ADDENDUM NO. 3

GARRETT COLLEGE MULTIPURPOSE FIELD SITE PREP

Date of Issue: December 30, 2022

SPECS JOB NO. 5593

MULTIPURPOSE FIELD SITE WORK
GARRETT COLLEGE
PROPOSED SITE PLAN

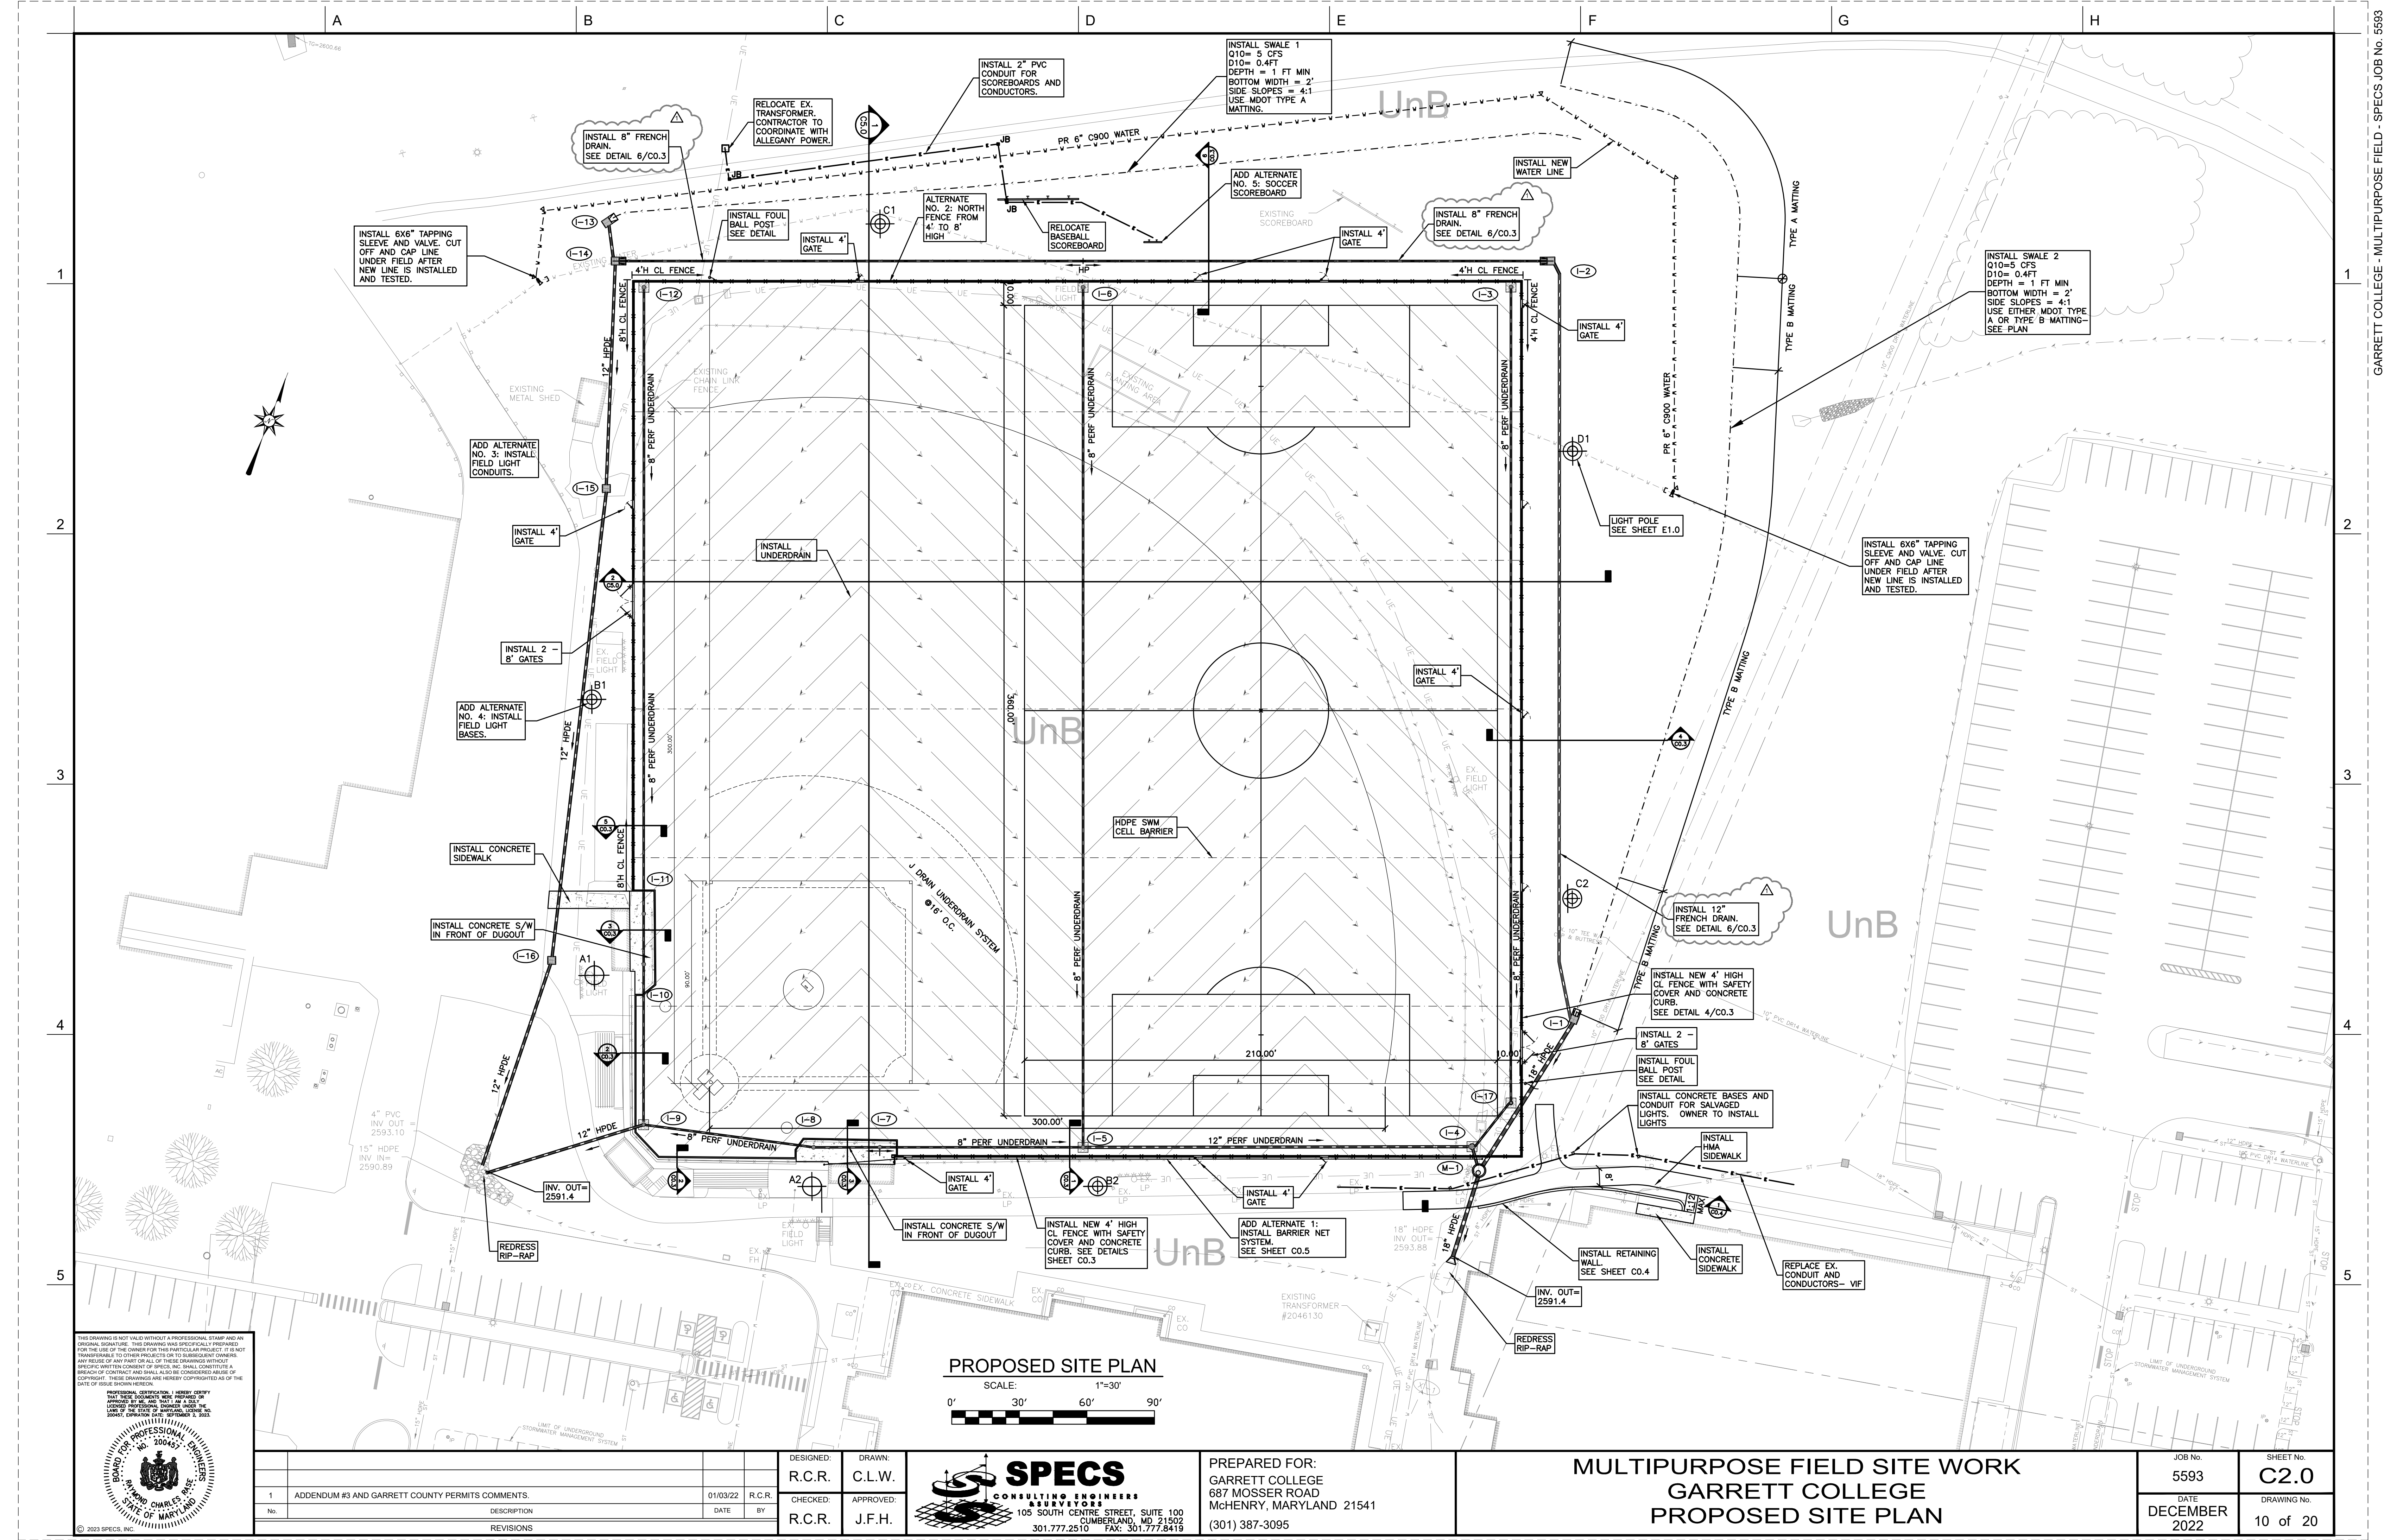
3. **REPLACE** Sheet C0.2 with revised sheet. Added invert in to Inlet I-14. Also revised detail 6 to reflect different French drain pipe sizes.
4. **REPLACE** Sheet C0.3 with revised sheet. Revised Detail 6.
5. **REPLACES** Sheet C2.0 with revised drawing. **CHANGE** diameter of French drain pipe from I-2 to I-1 from 8" to 12" HDPE. **ADD** 8" PERF UNDERDRAIN note for French drain pipe from I-2 to I-14.
6. **REPLACE** Sheet C4.0 with revised sheet. Sequence of Construction was revised.
7. **REPLACE** Sheet C4.1 with revised sheet. Sequence of Construction was revised.
8. **REPLACE** Sheet C5.2 with revised sheet including added profile between I-14 and I-2. Note pipe is deflected in the middle to drain both ways.

EROSION AND SEDIMENT CONTROL PLAN -PHASE 1

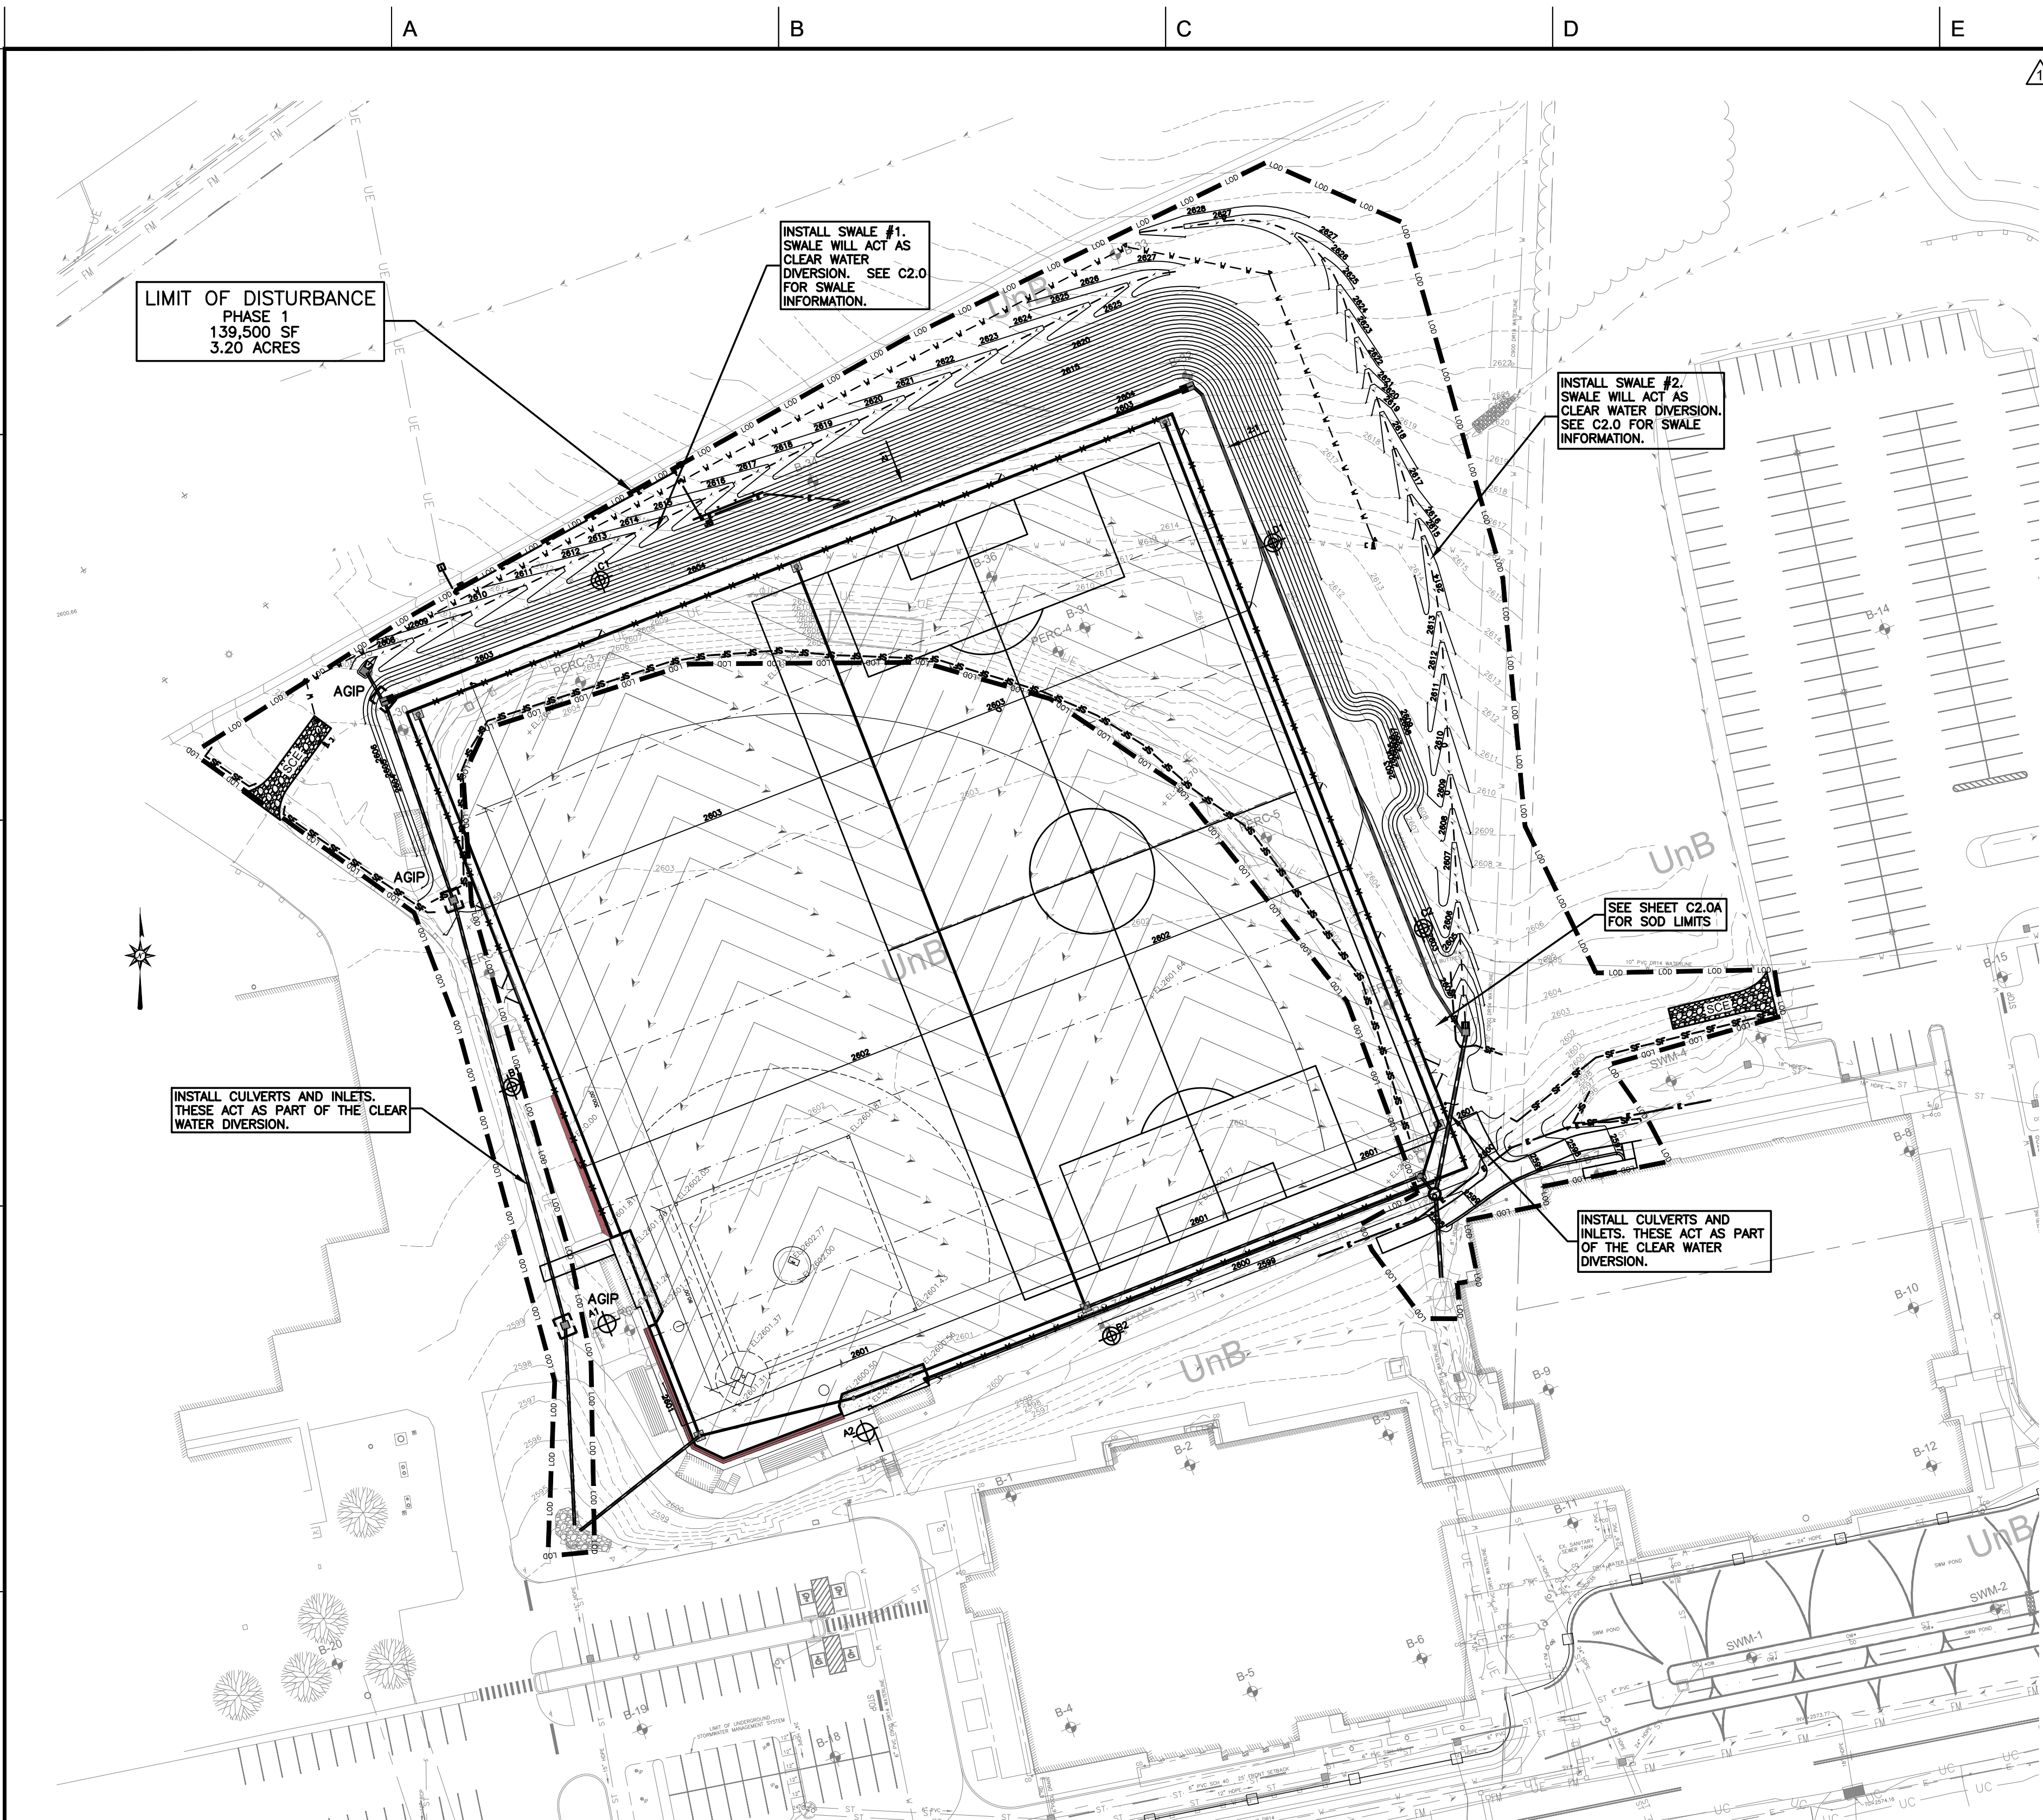
1. **REPLACE:** SHEET C0.0 with revised sheet. Change Table of contents and signature block.
2. **REPLACE** Sheet C4.0 with revised sheet. Sequence of Construction was revised. Note regarding contour elevations was changed. Added contour elevations. Revised spoil area to accommodate additional material.
